1. Background to the Easton Estate

File Ref: JB/JPC/P21-2417/01TN – Easton Estate

Subject: The A47 North Tuddenham to Easton Development – Deadline Submission Noise

The Easton Estate

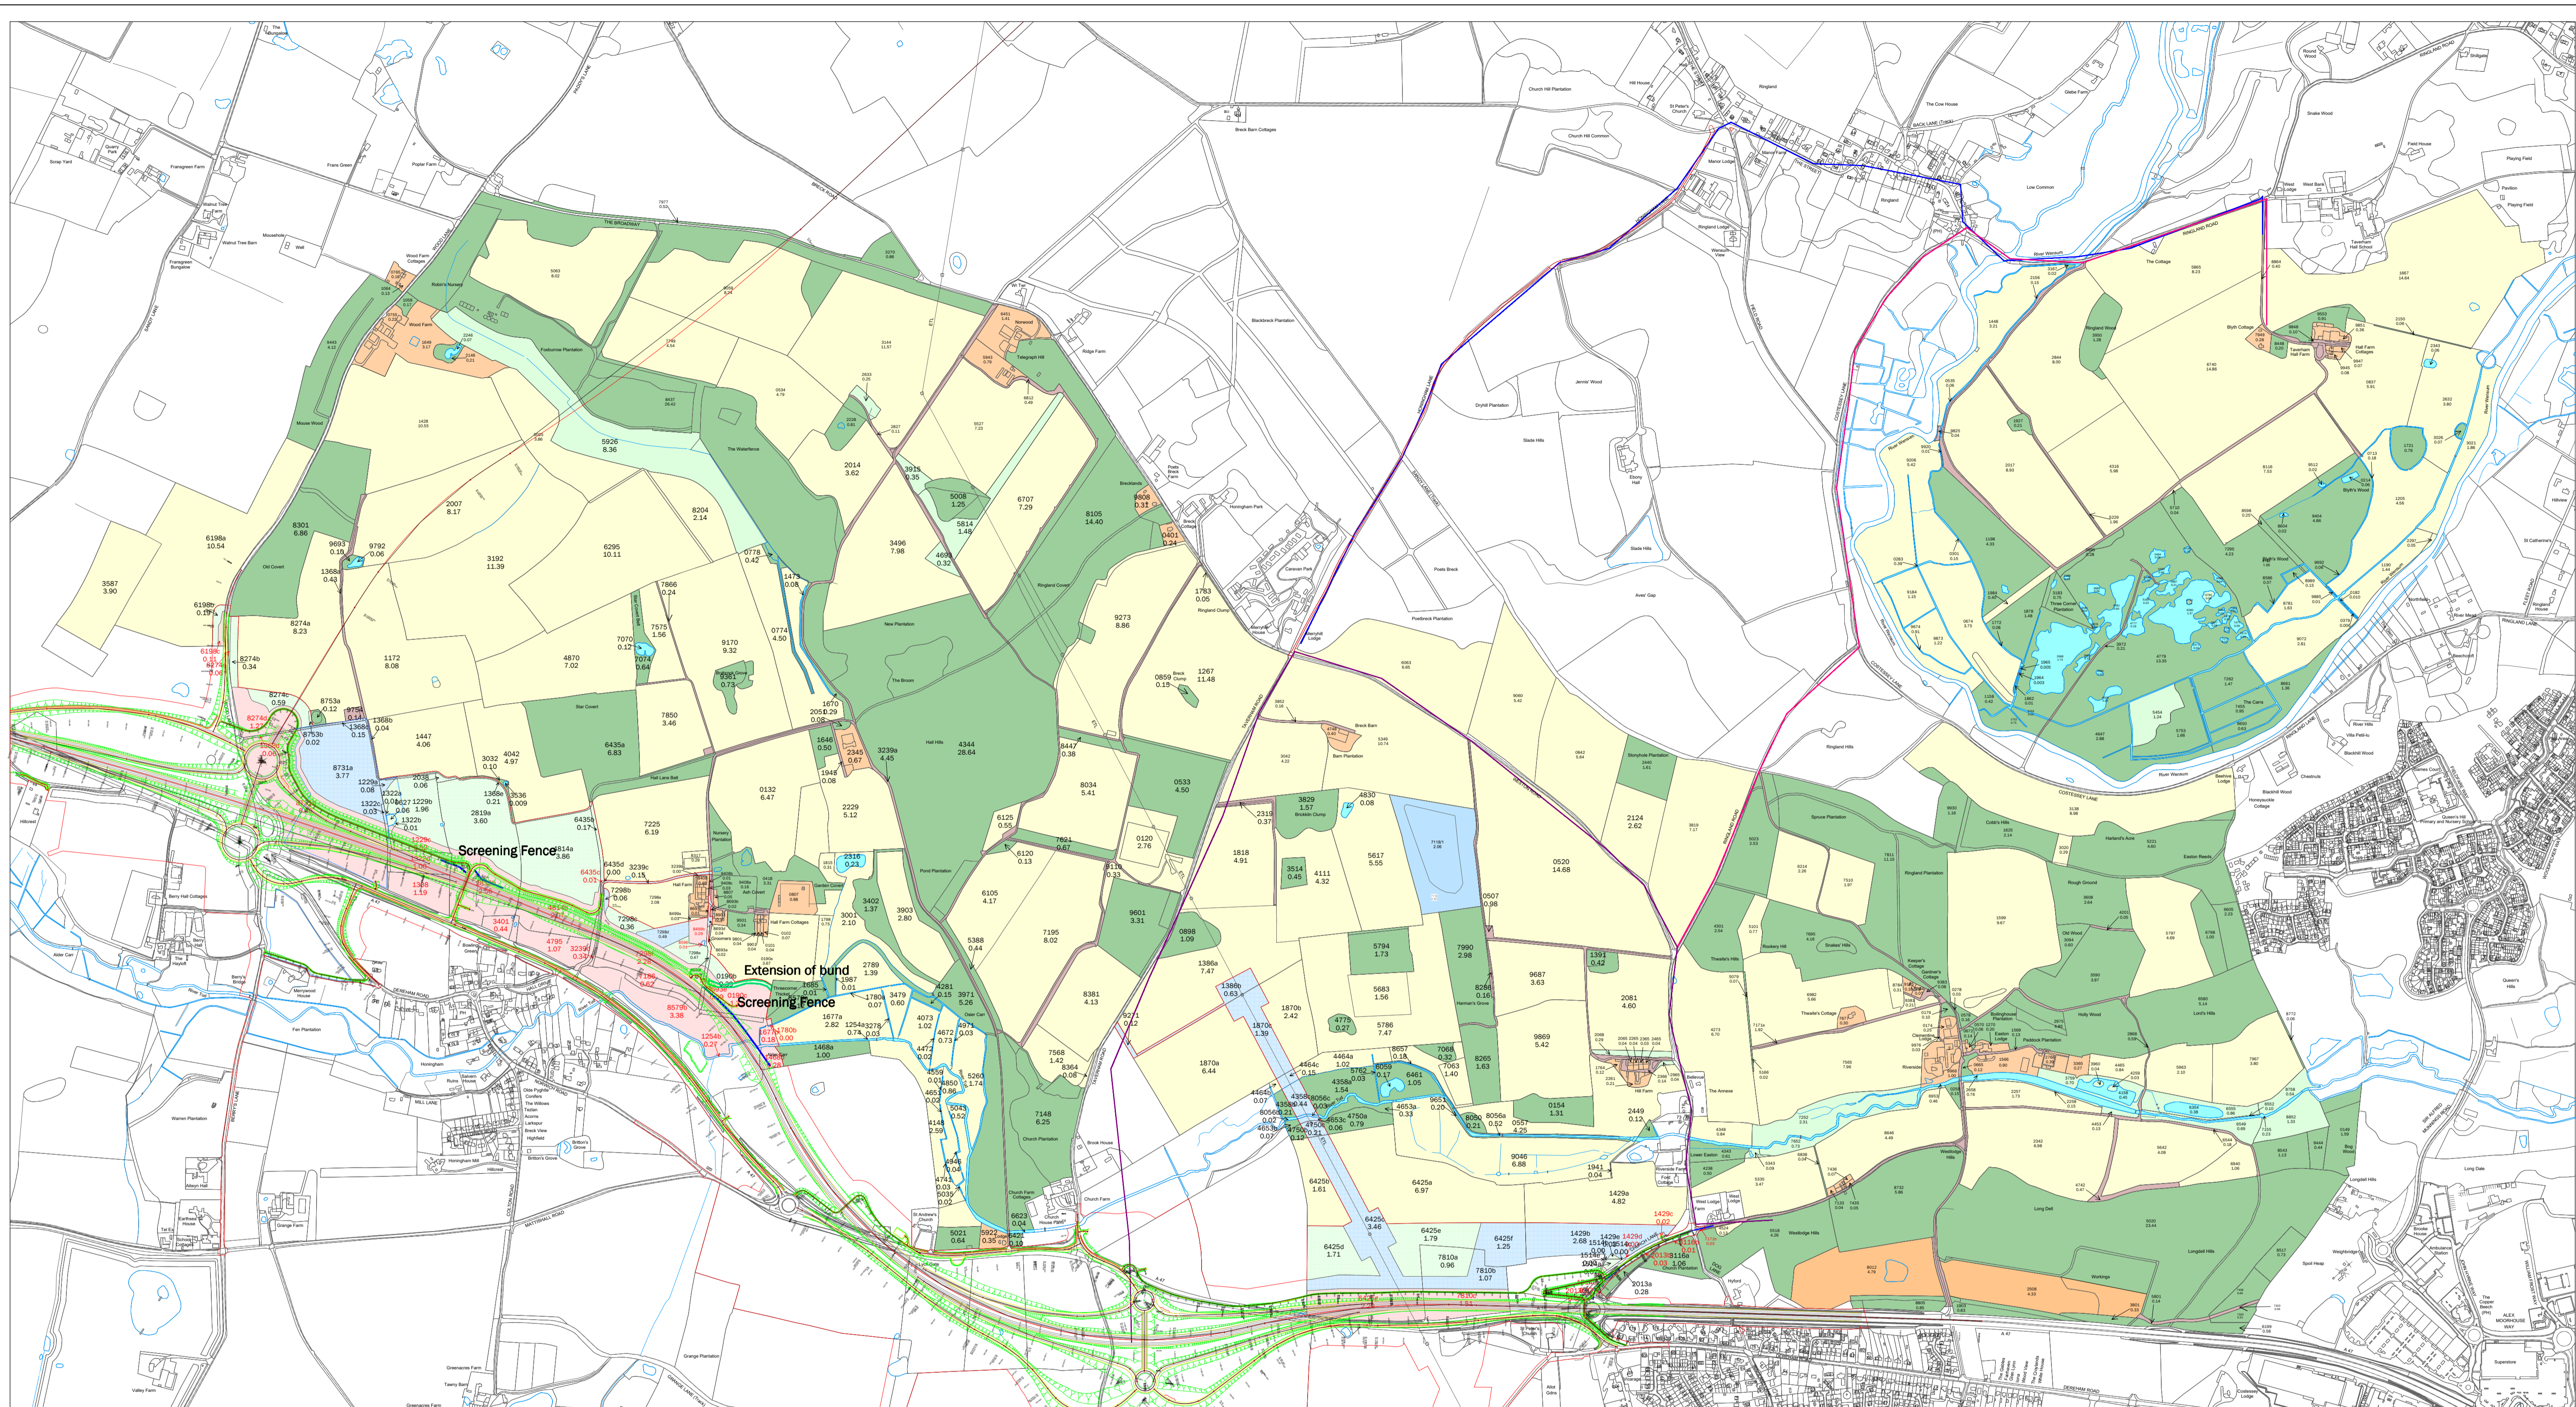
We understand more material will be available and have confirmed the estate request for a 3.5m to 4-metre-high embankment along the northern edge of the works or failing that, between Wood Lane and Honingham Church.

The embankment should be extended to the north of the attenuation lagoon near Hall Farm to screen headlights and visual intrusion as vehicles rise towards Hall Farmhouse, the buildings and the four cottages.

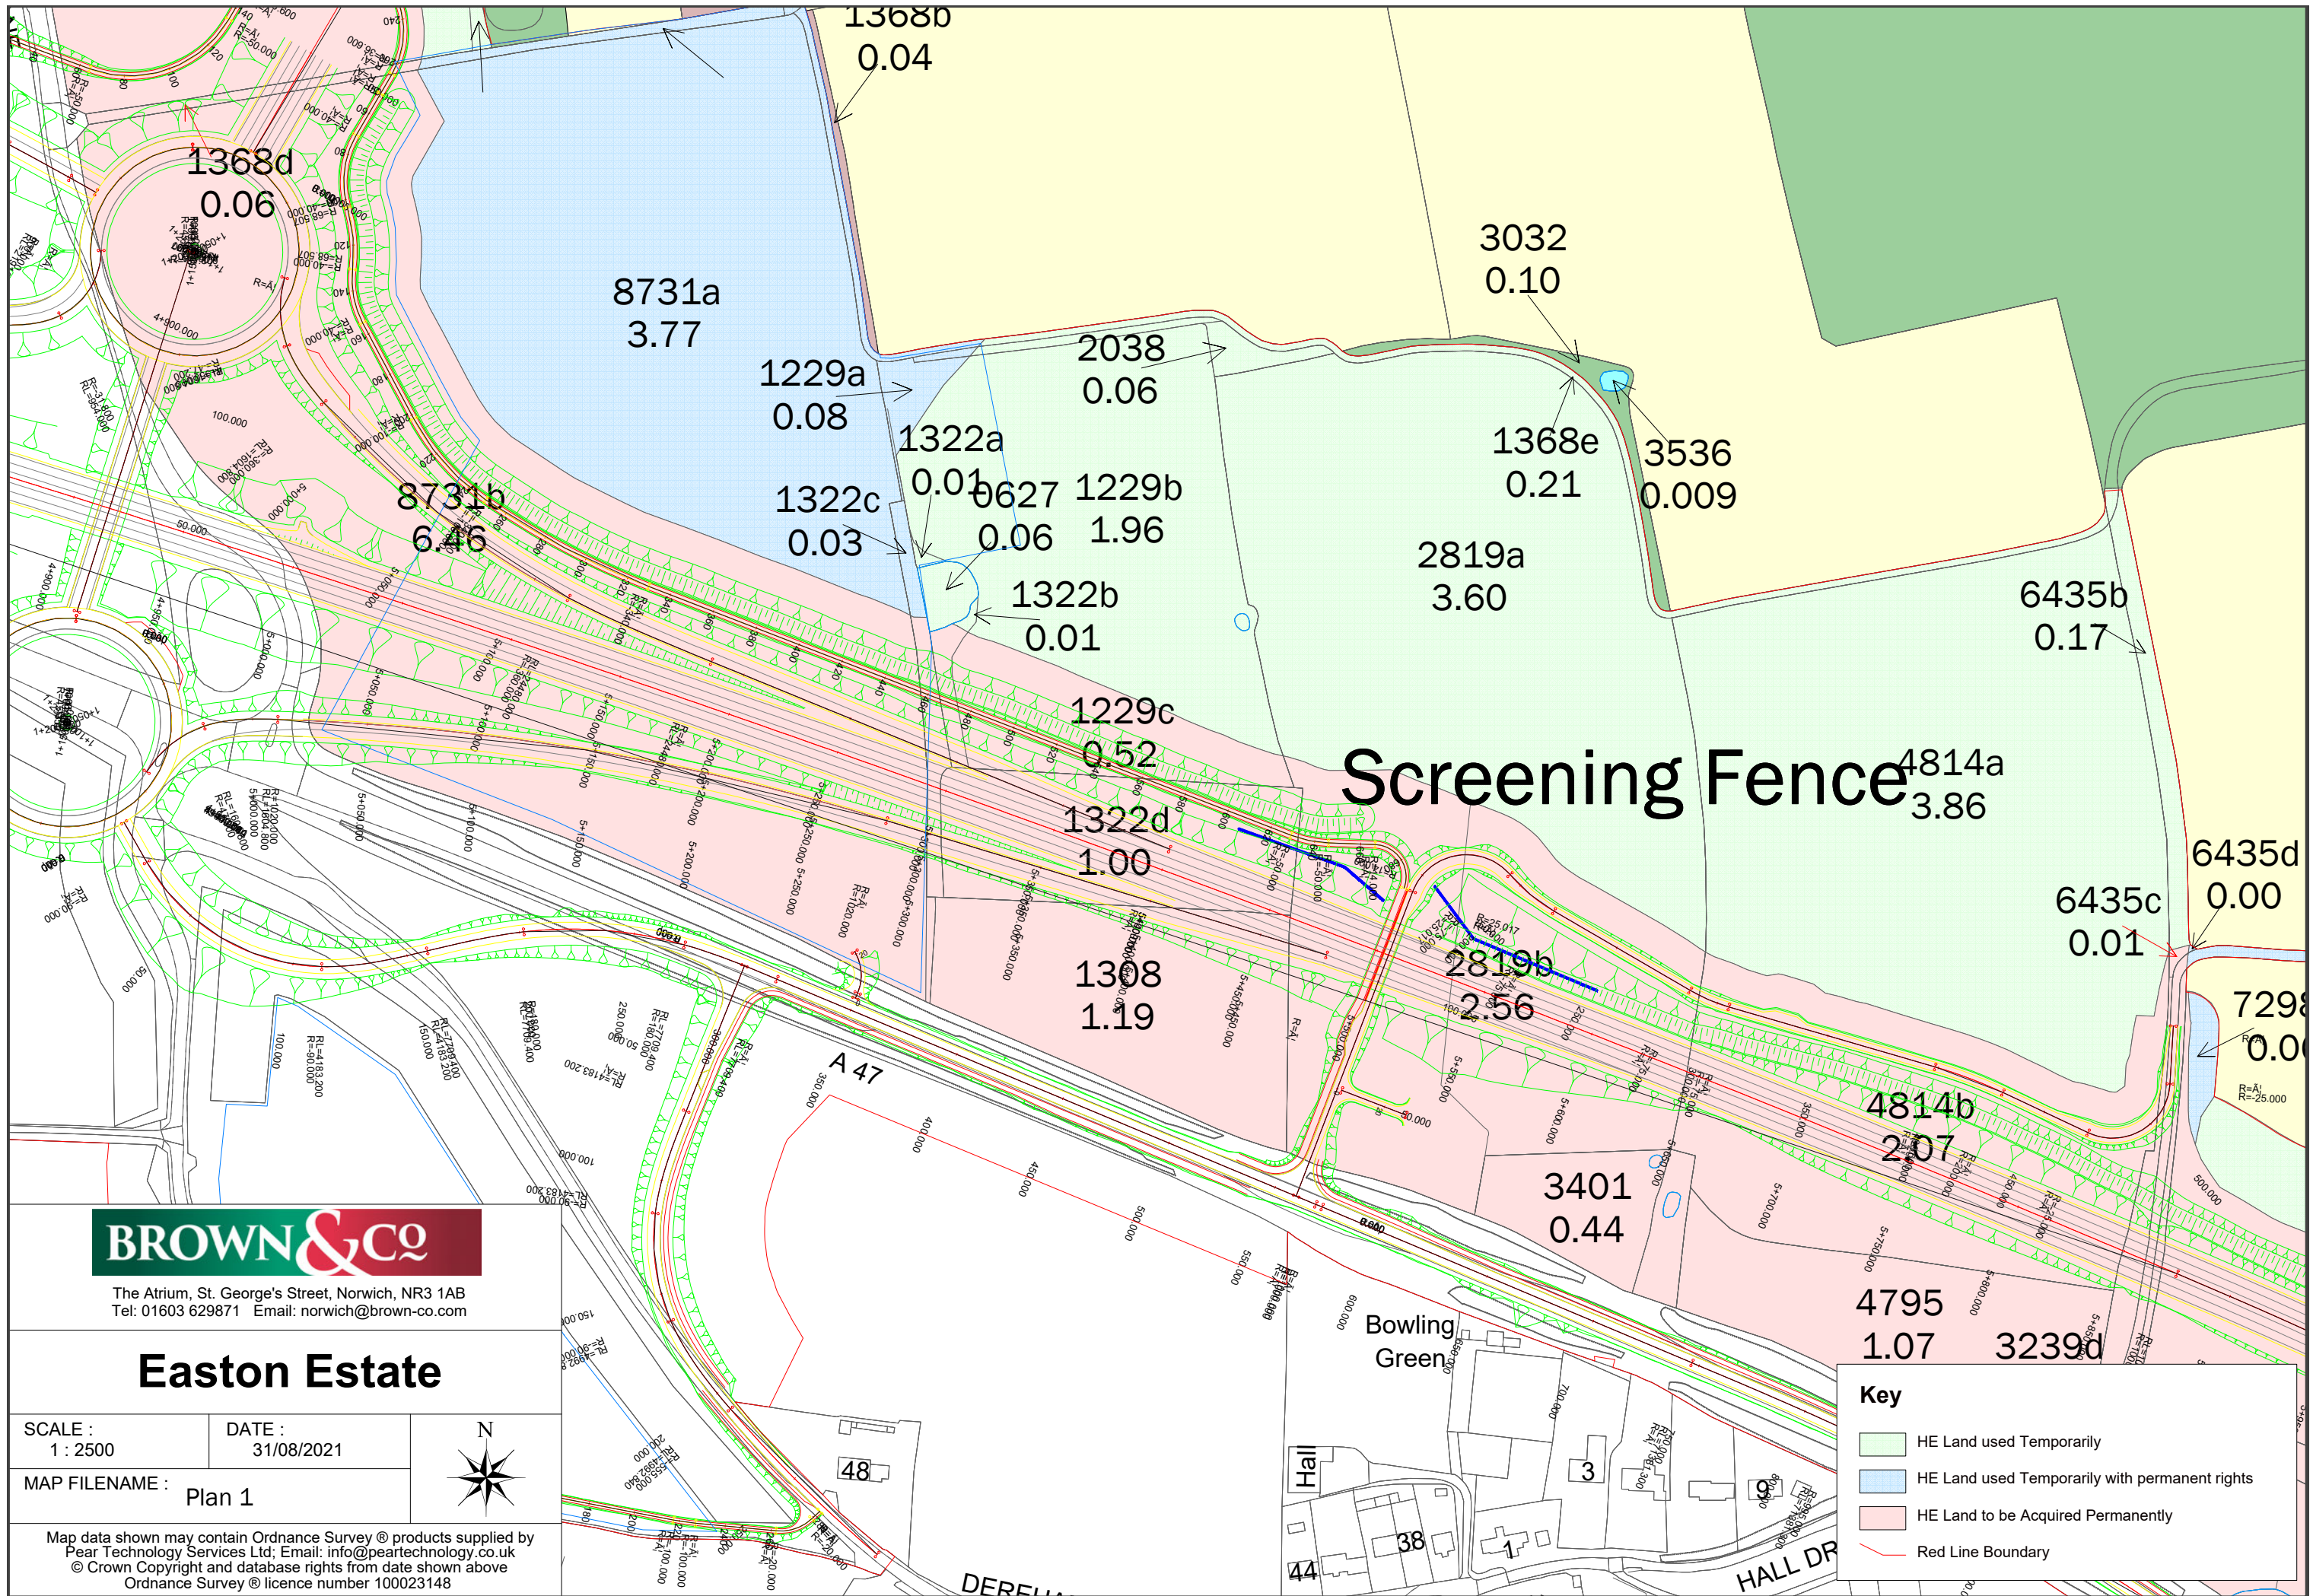
A screen fence situated on the adjacent embankment or the edge of the carriageway and carefully designed is likely to mitigate impact from what is a relatively short section of road.

MAP FILENAME : Plan 1

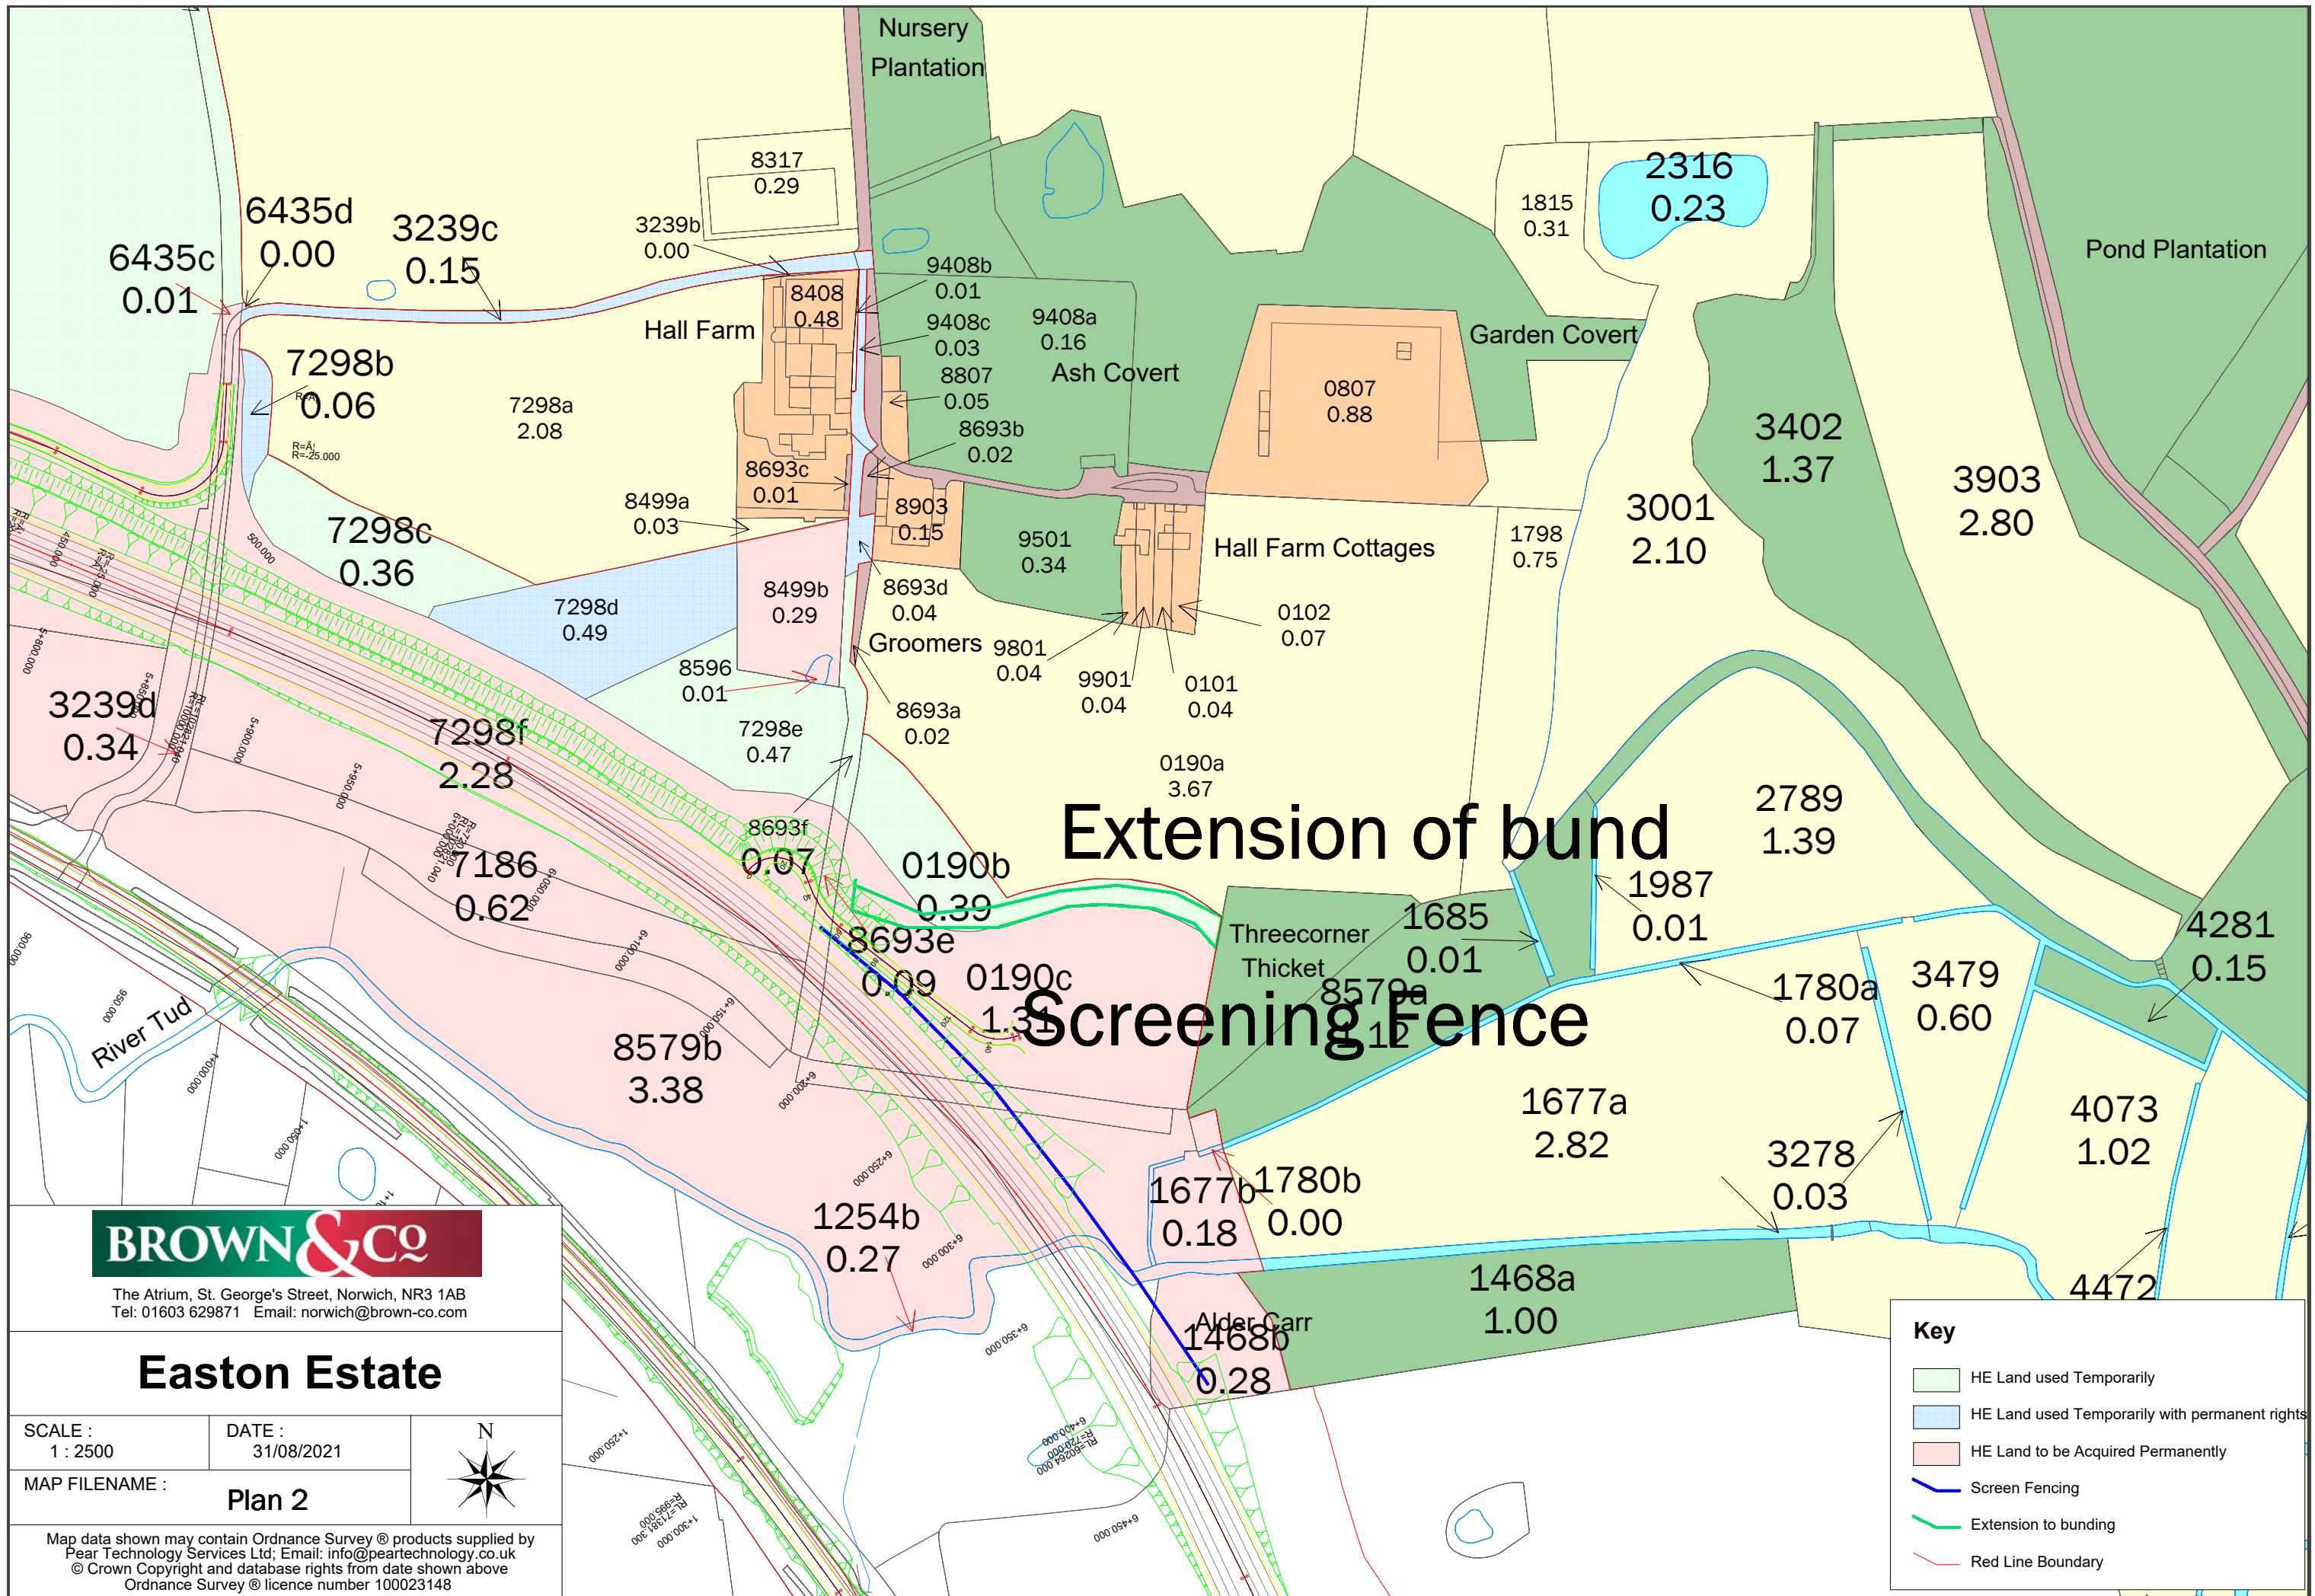
To benefit the residential properties at Hall Farm a fence should be installed from the edge of the woodland west of Honingham Church to screen headlights and vehicles before the proposed bank has any impact, unless the embankment is made significantly higher.
